STANDARD DEPARTURE CHART - INSTRUMENT

RJNH / HAMAMATSU

ATSUMI FIVE DEPARTURE

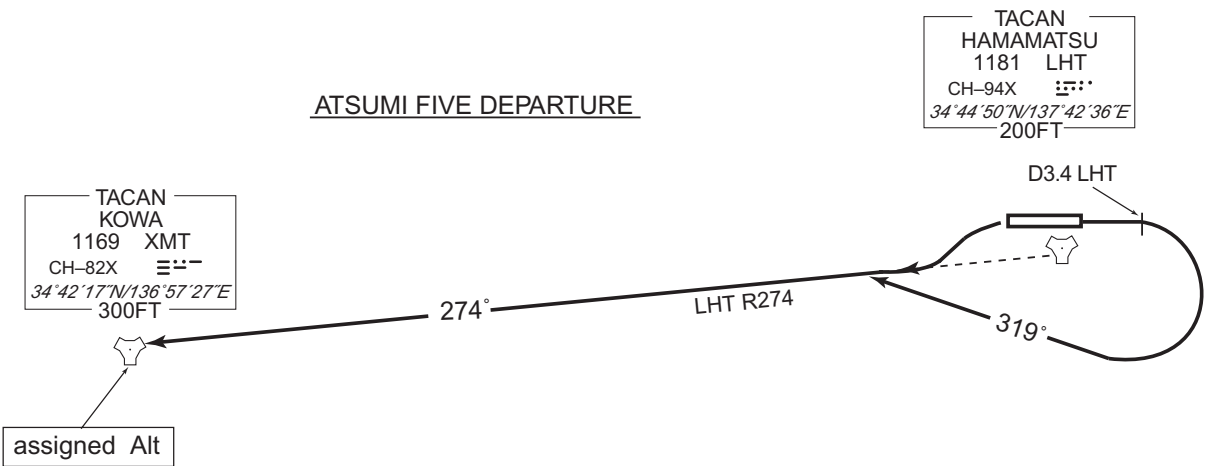
CHANGE : PROC renamed. PROC course. Note deleted.

HAMAMATSU REVERSAL THREE DEPARTURE

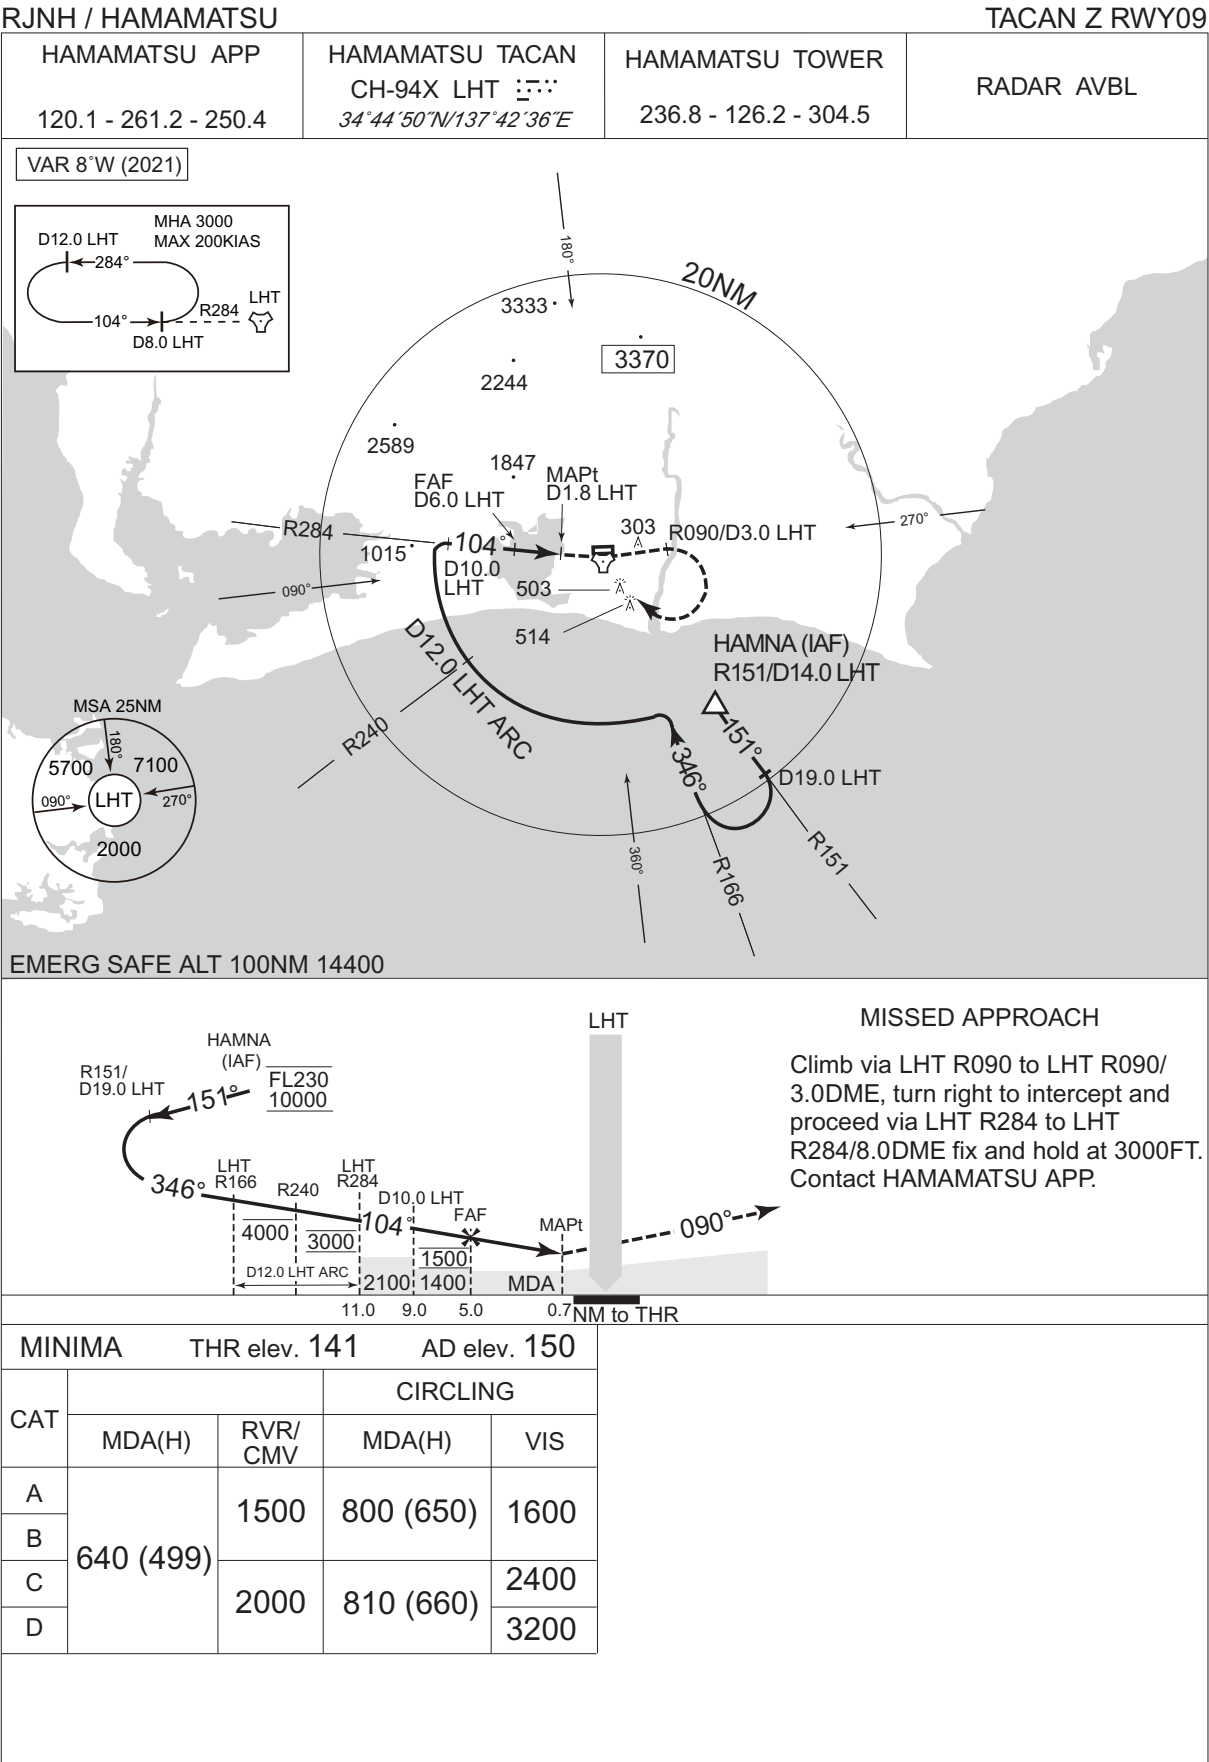
CHANGE : PROC renamed. PROC course. Note deleted.

TACAN Y RWY09

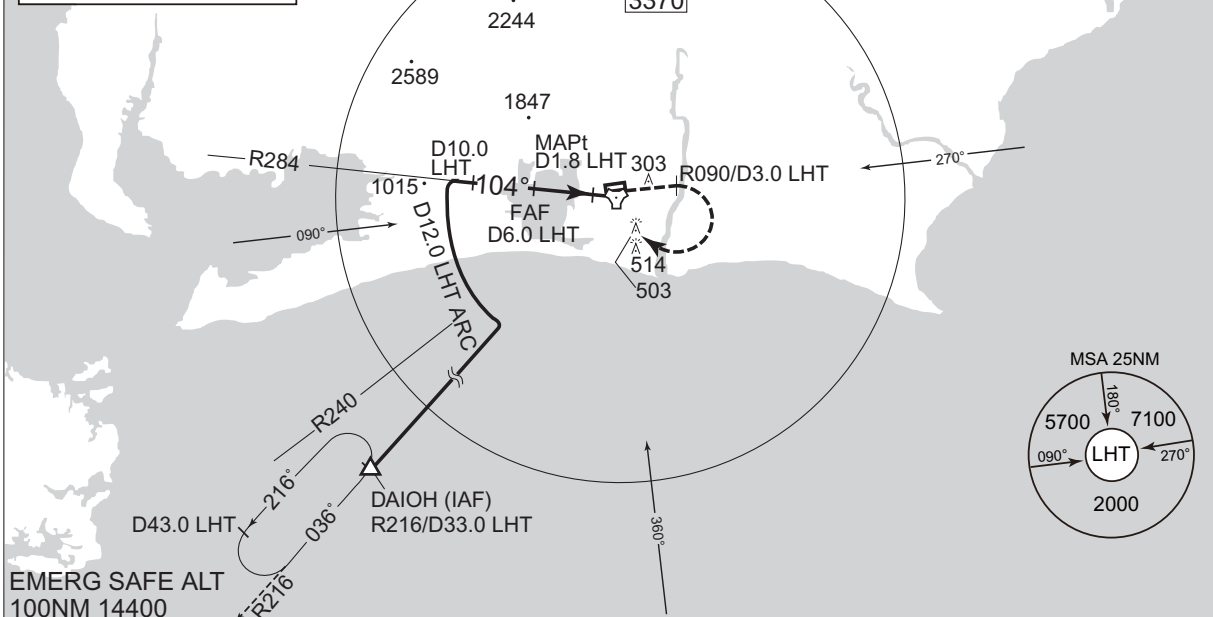
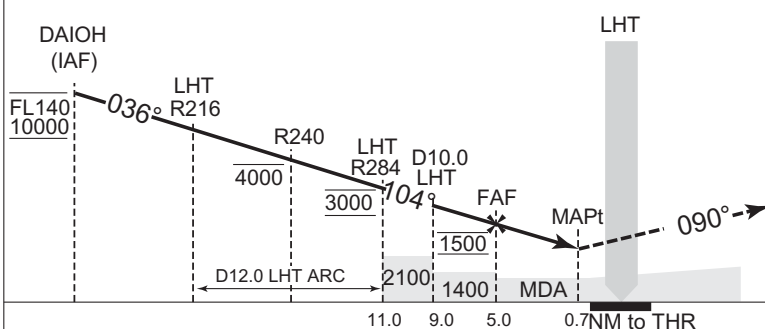
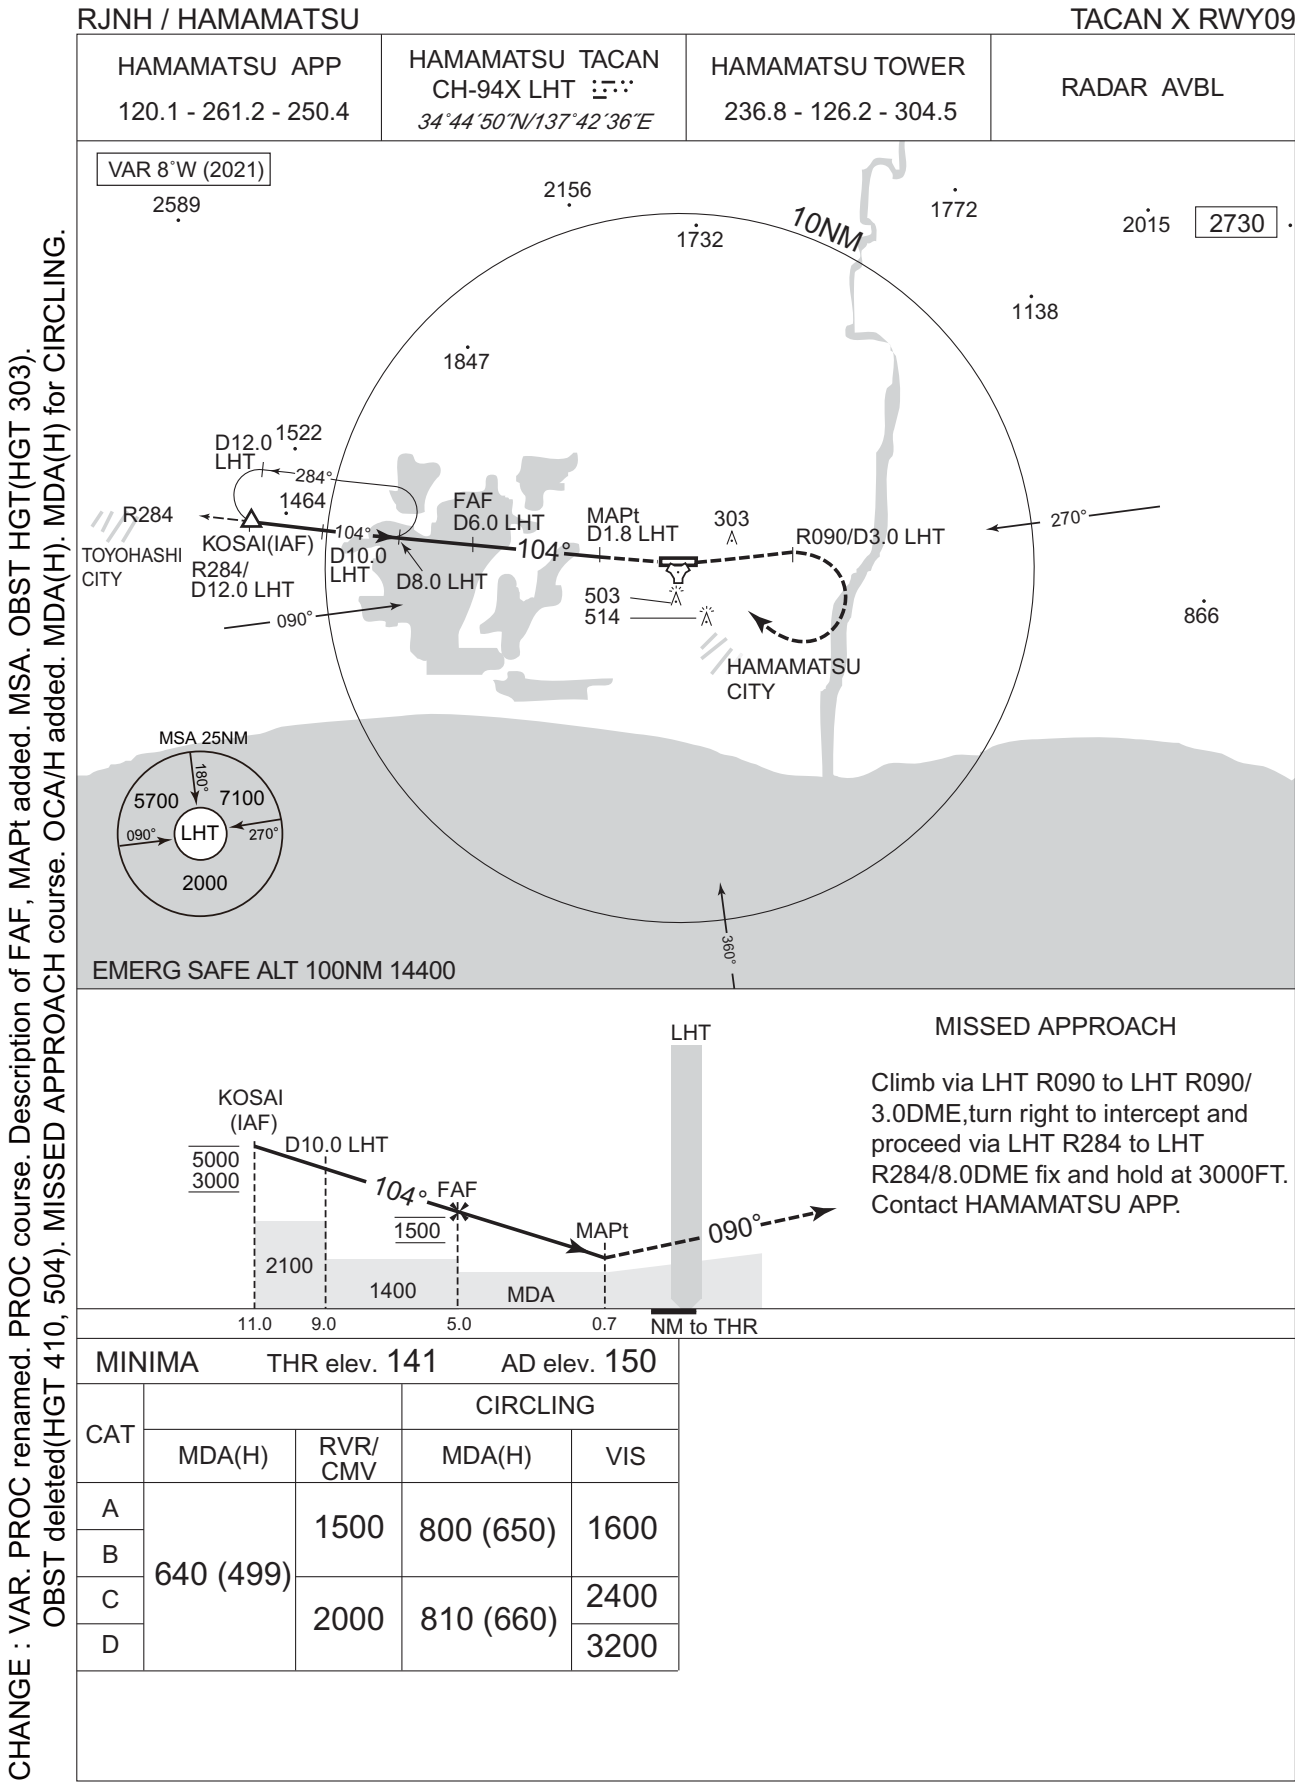
CHANGE : VAR. PROC renamed. PROC course. Description of FAF, MAPt added. MSA. HLDG pattern added. OBST added(HGT 303).  
OBST deleted(HGT 410, 504). MISSED APPROACH course. OCA/H added. MDA(H). MDA(H) for CIRCLING.

CHANGE : VAR. PROC renamed. PROC course. Description of FAF, MAPt added. OBST added(HGT 303).  
OBST deleted(HGT 410, 504). MISSED APPROACH course. ALT restriction(DAIOH). OCA/H added. MDA(H) for CIRCLING.

TACAN Z RWY27

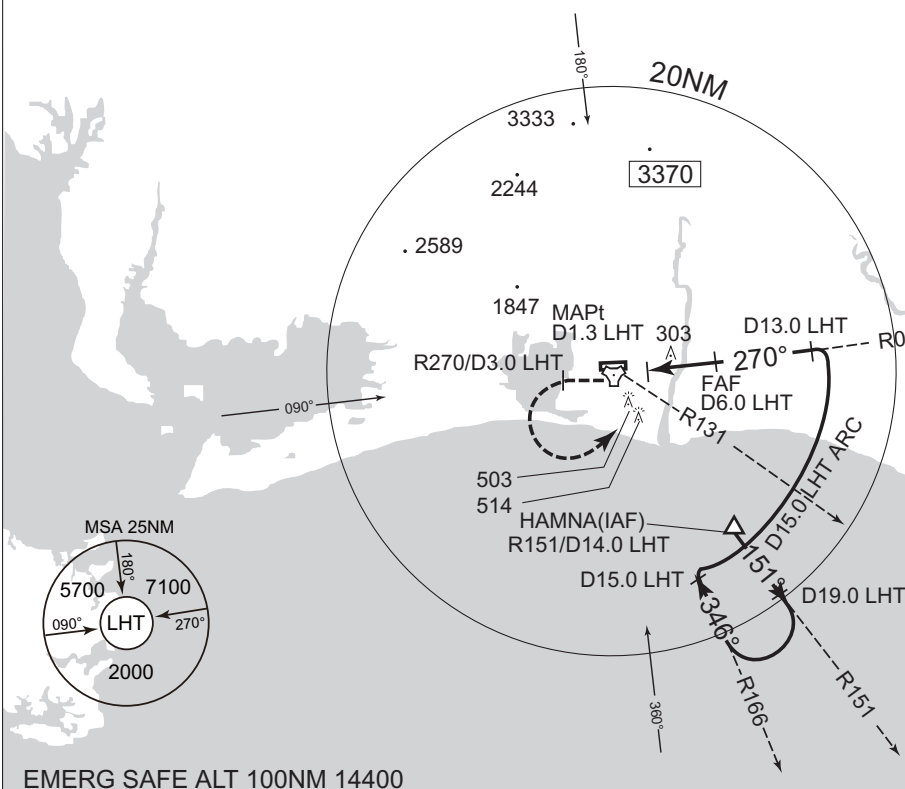
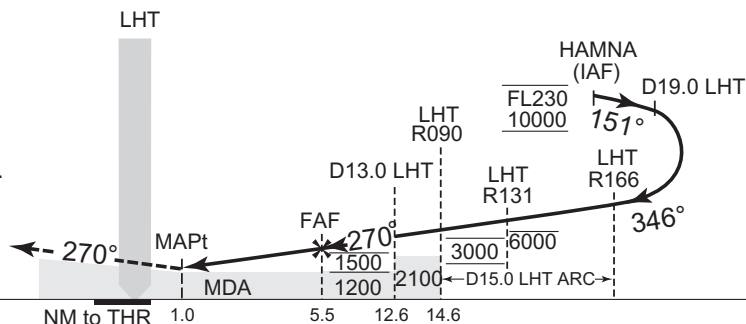
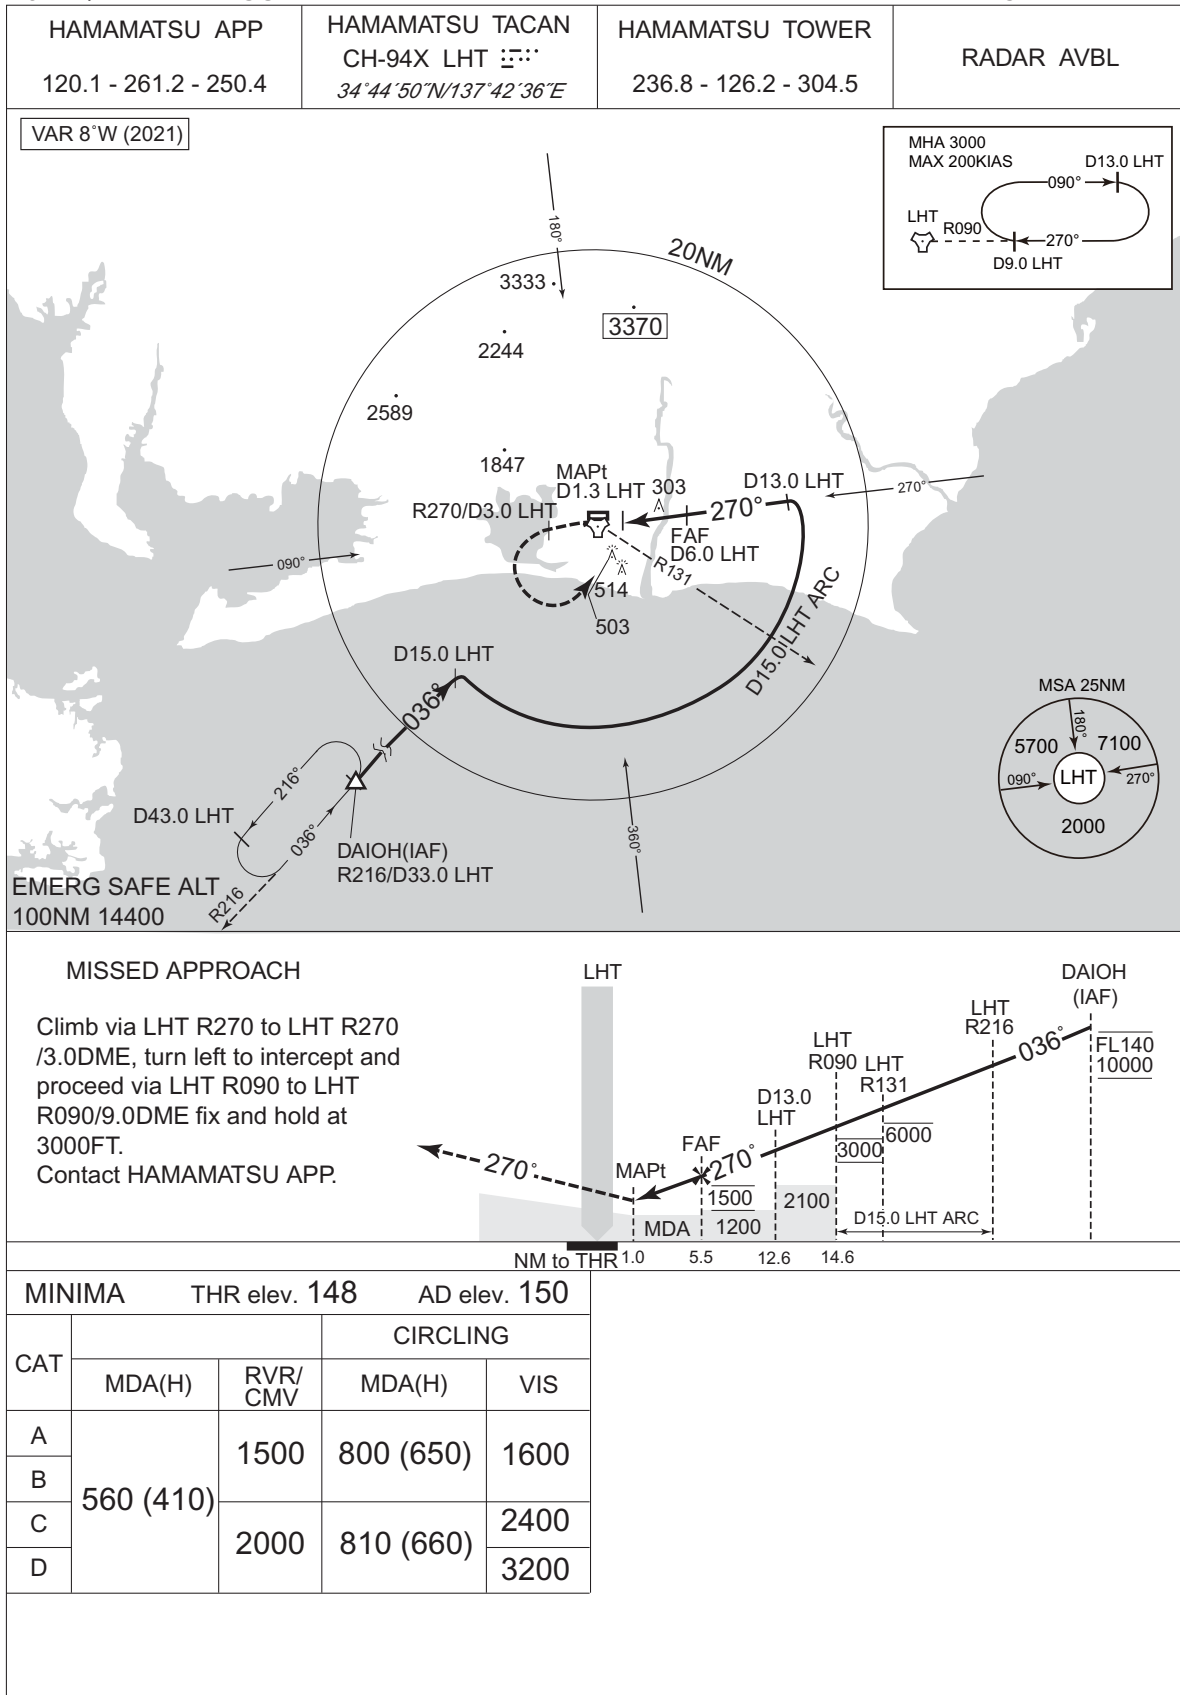
CHANGE : VAR. PROC renamed. PROC course. Description of FAF, MAPt added. OBST added(HGT 303).  
OBST deleted(HGT 410, 504). MISSED APPROACH course. ALT restriction(LHT R090). OCA/H added. MDA(H). MDA(H) for CIRCLING.

TACAN Y RWY27

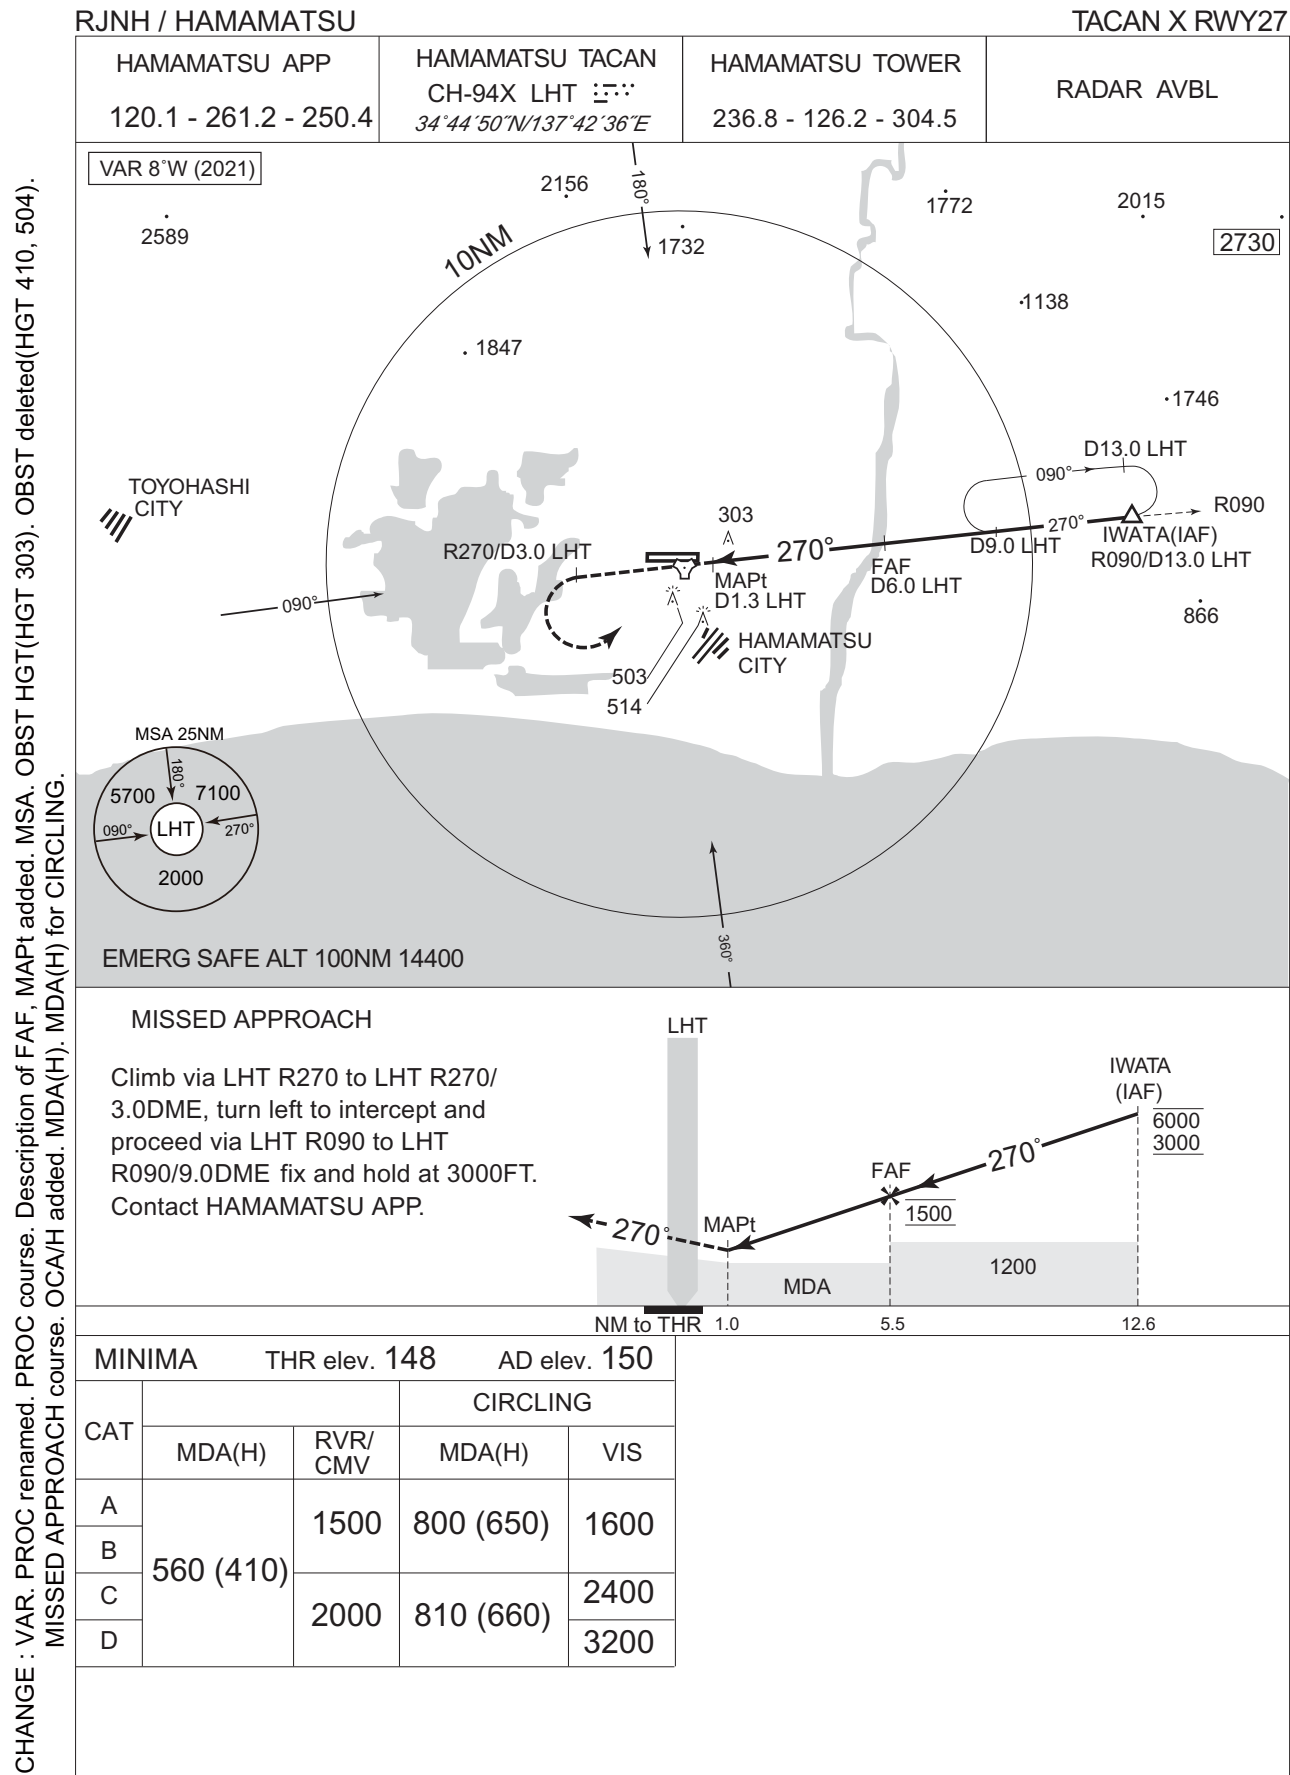
CHANGE : VAR. PROC renamed. PROC course. Description of FAF, MAPt added. MSA. OBST HGT(HGT 303). OBST deleted(HGT 410, 504). MISSED APPROACH course. OCA/H added. MDA(H). MDA(H) for CIRCLING.
